ADDENDUM NO. 1.0

Issued by: Sacramento City Unified School District

**Project: Project #: 0163-464
John Cabrillo ES Telecenter Upgrade Project**

Figure 4.
Cisco Catalyst 9300 Series Dual Redundant power supplies

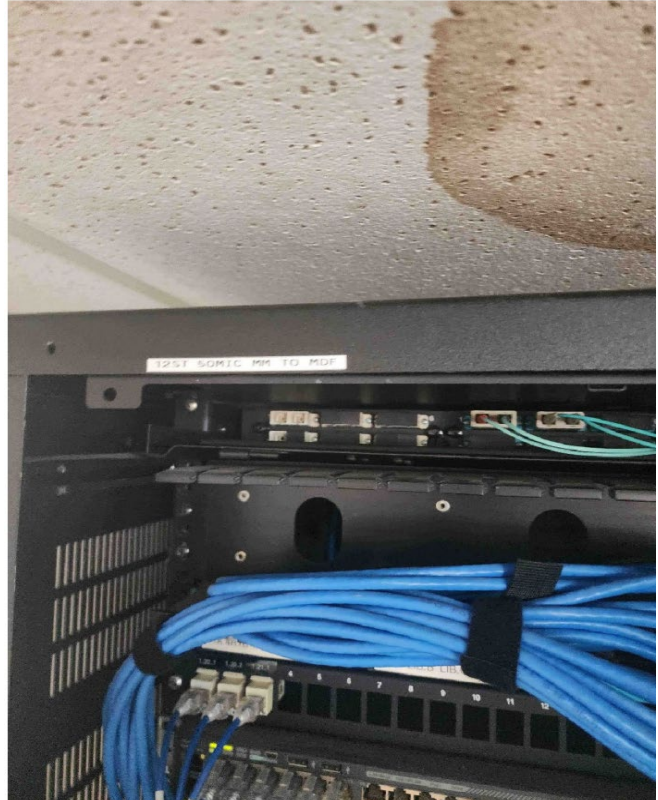
Question: On page 60 of the specifications, it calls for a, “Cisco #C9300L-48PF-4X-EDU [switch] with Cisco #PWR-C1-1100WAC-P and Cisco #PWR-C1-350WAC-P power supplies”. Please note the Cisco 9300 Series switches ship with (1) power supply by default, as noted below. With this in mind, can the District please confirm if the (2) additional power supplies are still required to be contractor furnished and installed?

The plans and specifications do not call for any SFP/SFP+ fiber optic transceivers for the new Cisco switches mentioned above. The only connectivity called for is a Cisco Twinax direct attach copper cable (Part# SFP-H10GB-CU1M). It is presumed these new switches will be stacked via this cable to the existing Cisco switches. If that is not the case, can the District please clarify the following questions:

- a. The part number and quantity of Cisco SFP/SFP+ transceivers required. *Please note this campus appears to be fed by multi-mode fiber*
- b. The part number and quantity of any other Cisco network-related components (i.e., stacking cables, stacking modules, etc.).

- The power supplies listed are the total power supplies required.
- Provide and install one Cisco C9300-NM-2Y SFP module in each new switch in each IDF and one Cisco C9300-NM-8X SFP module in the Head End switch.
- Provide and install one Cisco SFP-10G-LR single-mode transceiver and one Cisco SFP-10G-LRM multi-mode transceiver in each new switch in each IDF.
- Provide and install one Cisco SFP-10G-LR single-mode transceiver for each IDF with single-mode fiber optic cable and one Cisco SFP-10G-LRM multi-mode transceiver for each IDF with multi-mode fiber optic cable in the Head End switch. Provide one Cisco SFP-10G-LR single-mode transceiver to the District for each IDF with multi-mode cable.

- Verify model numbers with the District prior to ordering. Provide and install patch cables compatible with the transceivers and existing fiber adapter panels at each IDF and for each IDF at the MDF. For each multi-mode patch cable, provide the District a single-mode patch cord per specifications.

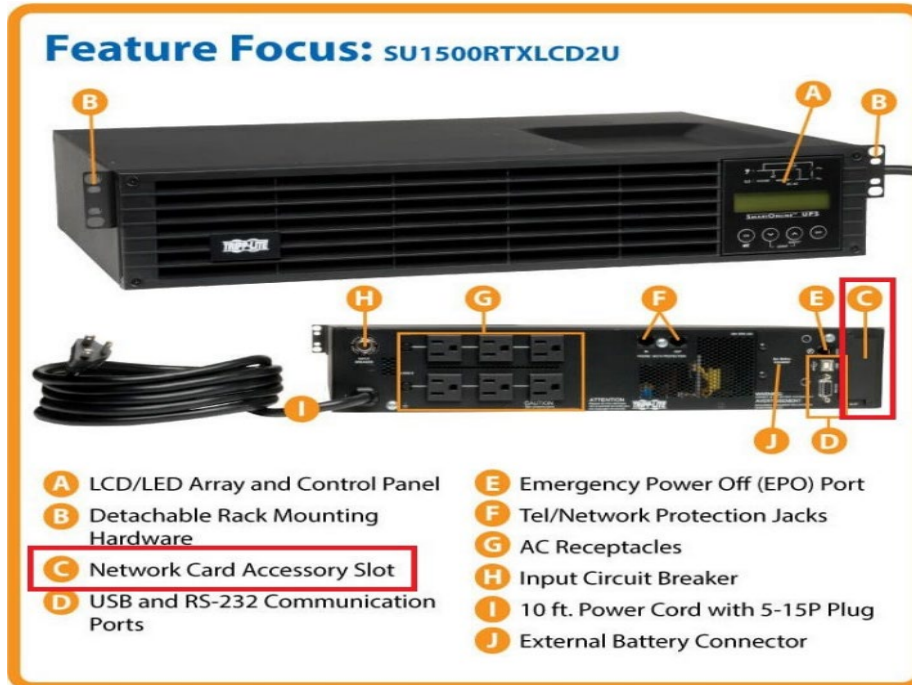
Question: On sheet E1.2, the plans call for new UPS battery backups to be contractor furnished and installed (Part #'s SU1000RTXLCD2U and SU1500RTXLCD2U). On page 38 of the specifications, it calls for "Provide and install Cat-6a connection from UPS data port to LAN". However, no network accessory cards have been called for in the plans or specifications. These units have the option of installing a network interface to achieve Ethernet connectivity (shown below). Having said that, can the District please clarify if network interface cards are required for these UPS battery backups? If so, please provide the part number and quantity of units required.

Provide one WEBCARDLX in each UPS.
